<b>Safety Alert</b>	
	<b>Flight Design GmbH</b> Sielminger Str. 51 D-70771 L.-Echterdingen Tel.: +49(0)7021 80460-0 Fax: +49(0)7021 80460-69 E-Mail: <a href="mailto:airworthiness@flightdesign.com">airworthiness@flightdesign.com</a>	<b>SA-LTUL-CTSW-06</b> <b>Revision 00</b>
	Date of Initial Publication: <b>16-May-2012</b> Publication Date of this Revision: <b>16-May-2012</b>

## Trim Tab Retrofit CTSW SA-LTUL-CTSW-06

##### 3.1 Airspeed Limitation

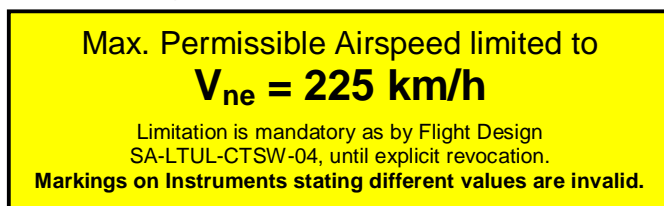
The never-exceed speed of the affected aircraft is reduced to  $V_{ne} = 225$  km/h.

This new limitation must be displayed in the cockpit and in the aircraft operating relevant manuals.

Print the following placard in color.

Install placard to the instrument panel, in direct vicinity to the airspeed indicator. When the aircraft is indicated with an EFIS, install close to the EFIS in a location, where the pilot must notice it when operating the aircraft.
